DIGITAL 	FCO	CATEG([F]	_	GE 1 F 8	
FIELD CHANGE (DRDER	NUMBER: DI	HW4X-F001	I	
APPLICABILITY: This FCO applies to MicroVAX 3100 Models 30, 40 and 80 with a DHW41/42 asynchronous communications option that uses a revision B03 logic board 54-20662-01. The DHW41/42 family includes: DHW41-AA and -BA for the Model 30; DHW42-AA, -BA and -CA for Models 40 and 80. Hereafter, this option will be referred to as DHW4X. ECO's 5420662-TW0001 and -TW001A apply to this FCO.					
PROBLEM & SYMPTOM: The DHW4X option will "lock-up" or "hang" at intermittent intervals, depending on customer application, because of lost interrupts caused by a failure on the rev. B03 DHW4X logic board 54-20662-01 to process data. Once "lock-up" occurs, any/all devices attached to the DHW4X cannot be stopped or cleared. (Continued on Page 2)					
SOLUTION: Replace the revision B03 logic board (54-20662-01) with part revision C03.

FCO	DHV	√4X-E	7001
d i g i t a 1		PAGE	2	OF	8
	1

Figure 1 - Generic Diagram of CPU Boards used in MicroVAX 3100-30, -40 & -80

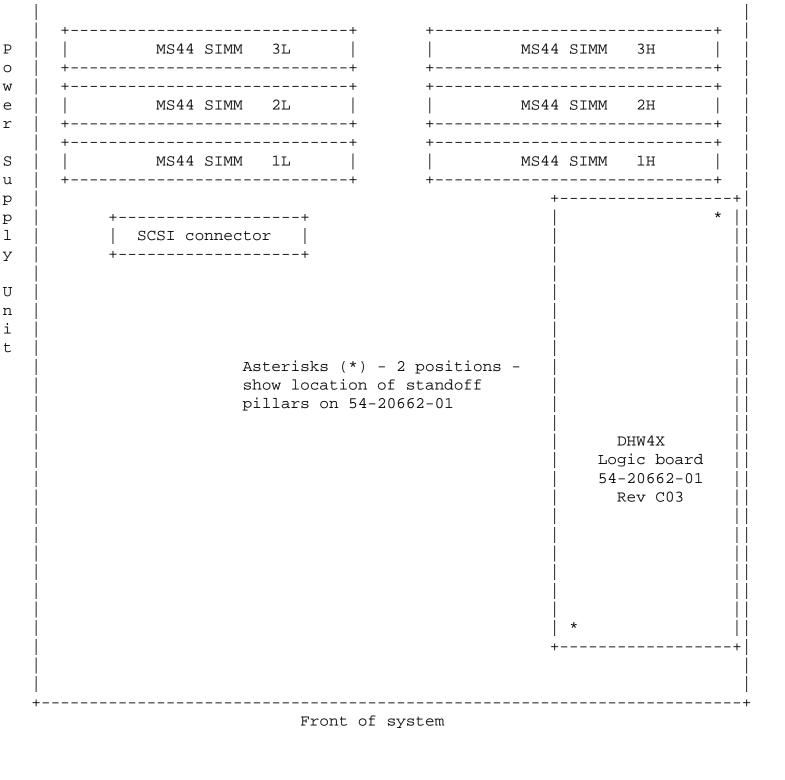
- 7. Remove and inspect the 54-20662-01 logic board to determine it's revision:
 - a. Refer to Figure 1 which shows the location of the 54-20662-01 logic board that needs to be removed.
 - b. Press the latch on one of the stand-off pillars and push up the corner of the 54-20662-01 logic board until the 54-20662-01 logic board is released from the stand-off pillar.
 - c. Press the latch on the other stand-off pillar and push up the corner of the 54-20662-01 logic board until the latch releases the 54-20662-01 logic board from the stand-off pillar.
 - d. Push up the 54-20662-01 logic board until the connectors on the 54-20662-01 logic board disengage from the connectors on the CPU board.

- 8. Re-install the desired revision level 54-20662-01 logic board: Ensure the board is at revision CO3. Follow Step 7 in reverse, then go to Step 9.
- 9. Re-install the mass storage drive mounting shelf/shelves: Follow Step 6 in reverse, then go to Step 10.
